TECHNICAL NOTE

PROJECT	:	Land adjacent Sefter School House, Sefter Road, Pagham
NOTE REF.	:	Acl673/21023/TN
NOTE TITLE	:	Additional Information requested by the LLFA
AUTHOR	:	Tafari Lewis
APPROVED	:	Tafari Lewis
DATE	:	11 th August 2022

This file note has been produced to provide additional information to Arun District Council (ADC) as lead local flood authority (LLFA) on drainage and flood risk for the proposed development of land adjacent Sefter School House, Sefter Road in Pagham.

Marshalls Table & Capping Layer Thickness

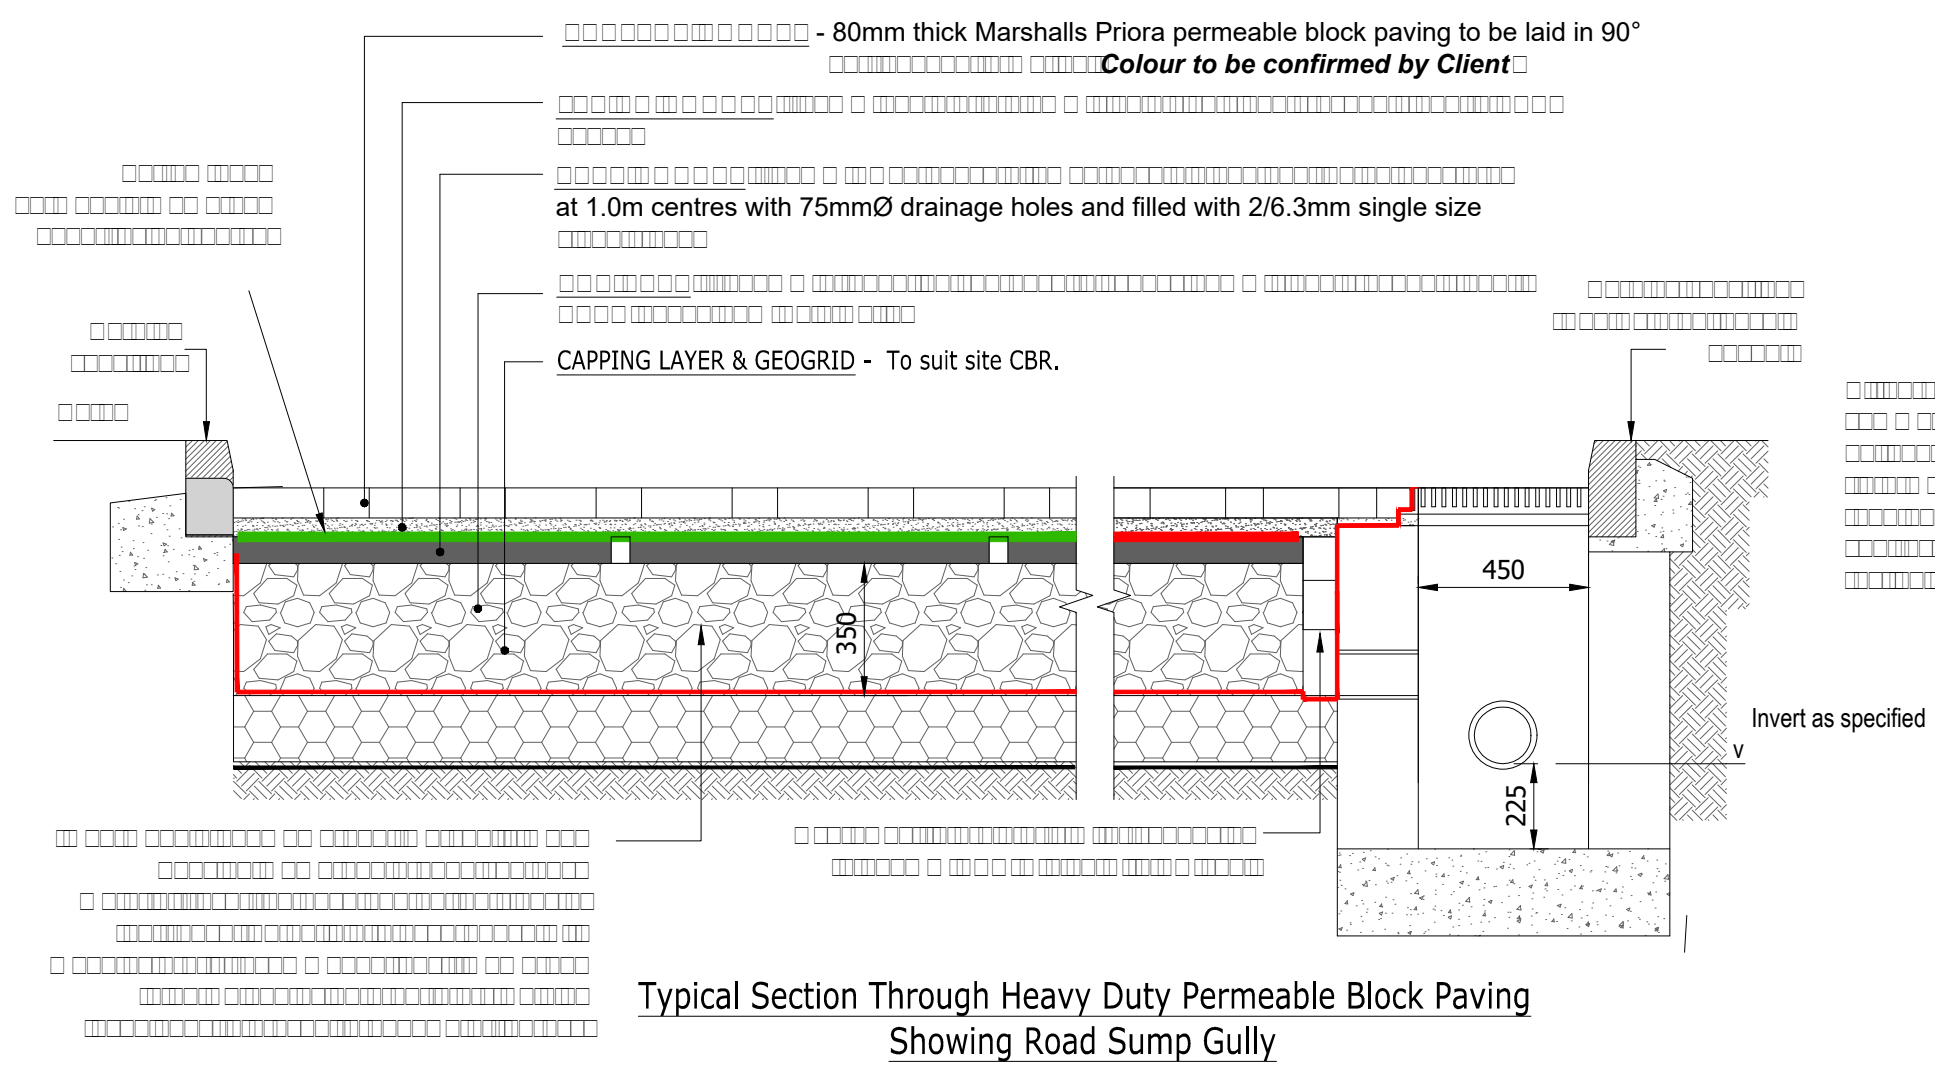
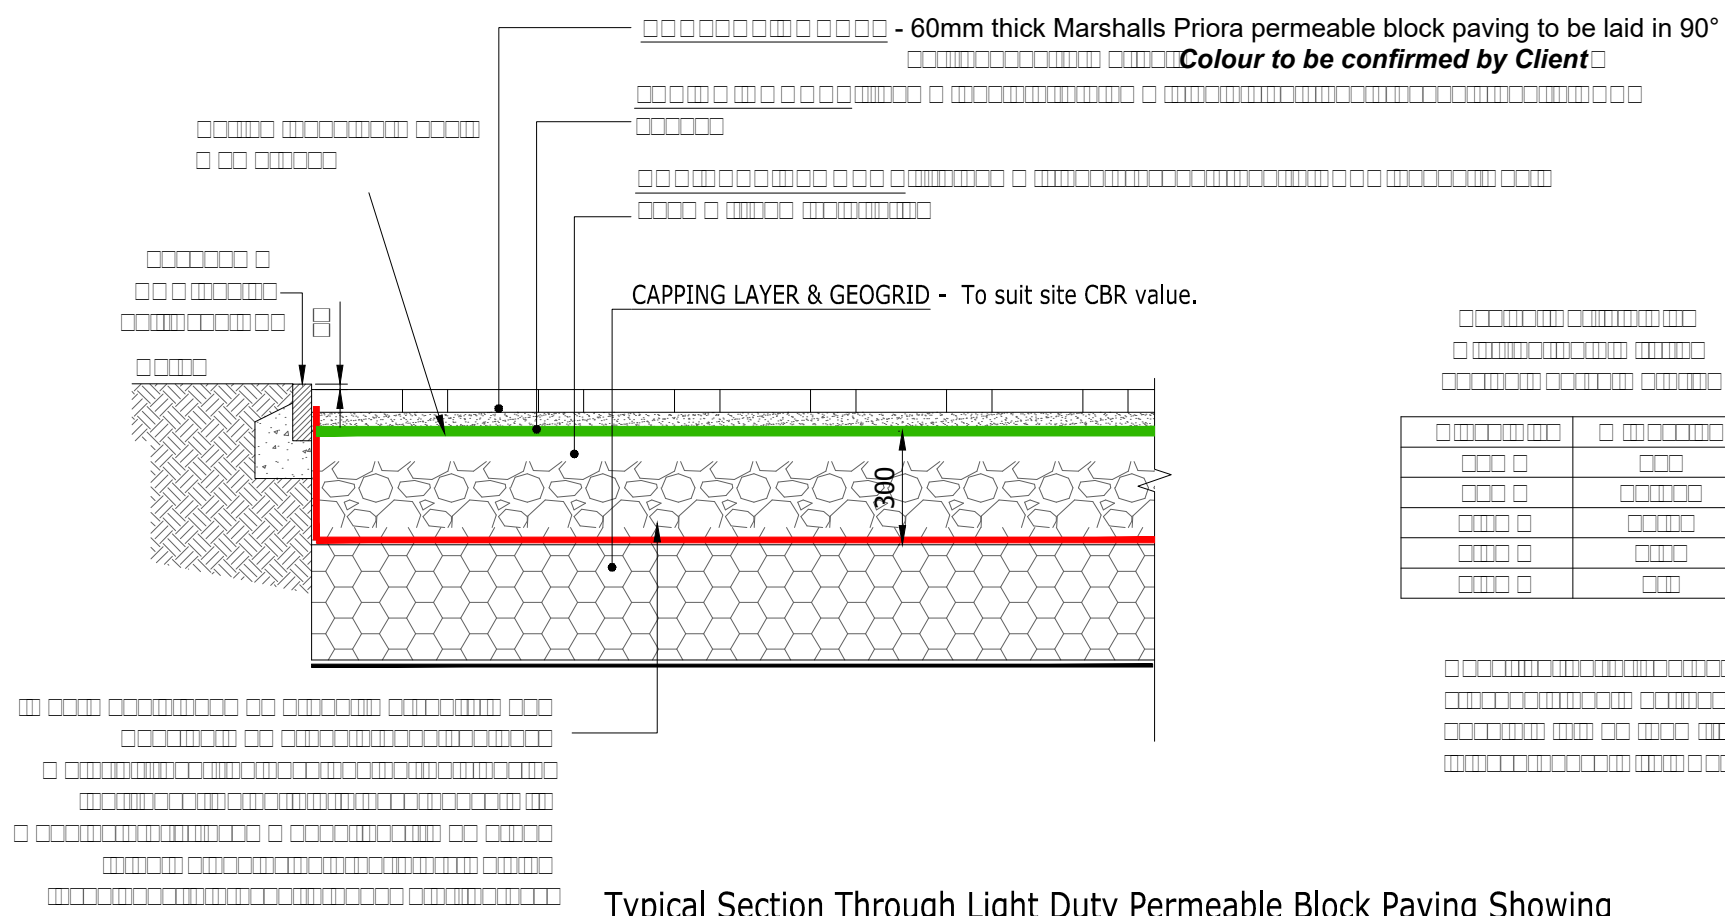
“The type of membrane surrounding the permeable paving sub-base / specification should be specified on the drawings.”.

Marshalls M380 tanking membrane has been specified. Pavement details are included within Appendix B.

Polystorm Attenuation Tank - Plan View

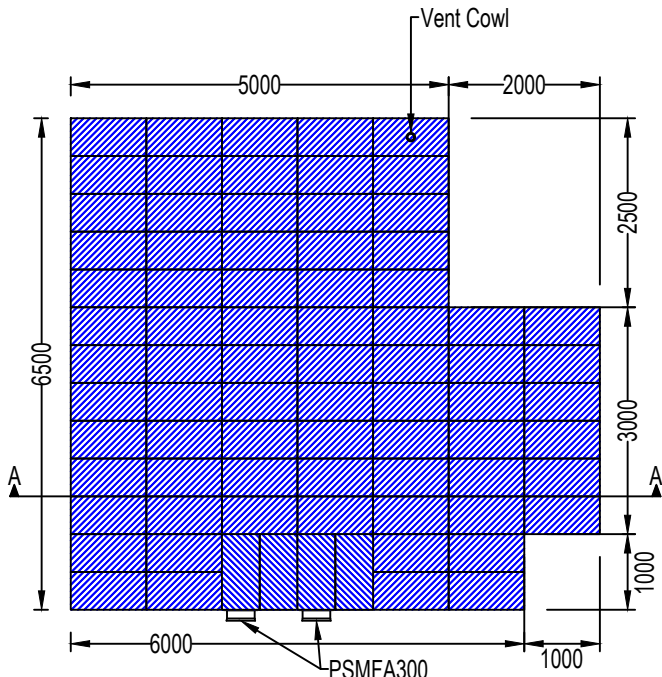
"Regarding the geo-cellular storage, there is a note on both the drainage layout plan and section detail of the storage tank which states "Polypipe Civils (or similar approved)". At DOC stage we require certainty that specifications will be followed, as any changes to the specification may impact associated calculations. As there is no mechanism for enforcing further review of such changes, which could result in significant changes to the design if different crates are approved, please can the applicant remove the "or similar approved" section of this comment from the drawings."

Noted. Reference to similar approved products has been omitted from the drainage layout and section details. Full manufacturer details for the scheme have been included within the drawing updates in **Appendix B**.

Plan Area	39.5m²
Tank Volume	31.6m³
Storage	30.02m³
Polystorm-R Units	79 (PSM1A)
Polystorm-Deep Units	79 (PSM5)

Swale Inlet Headwall Range

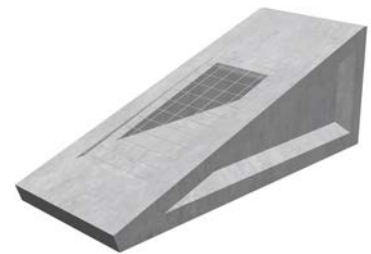
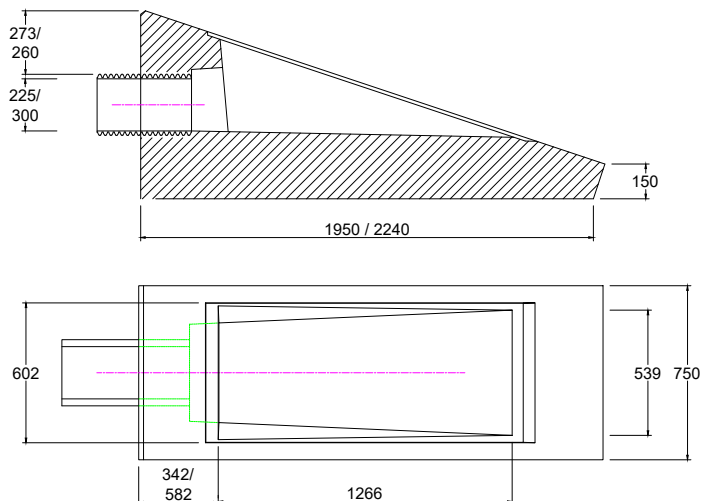
“All inlets into the pond must have headwalls. The inlet pipe from gully to the north west of the pond needs an outfall headwall on the drainage layout plan”.

Acknowledged. We have now shown an Althon inlet swale headwall for the gully connection and included details for the same in Appendix B.
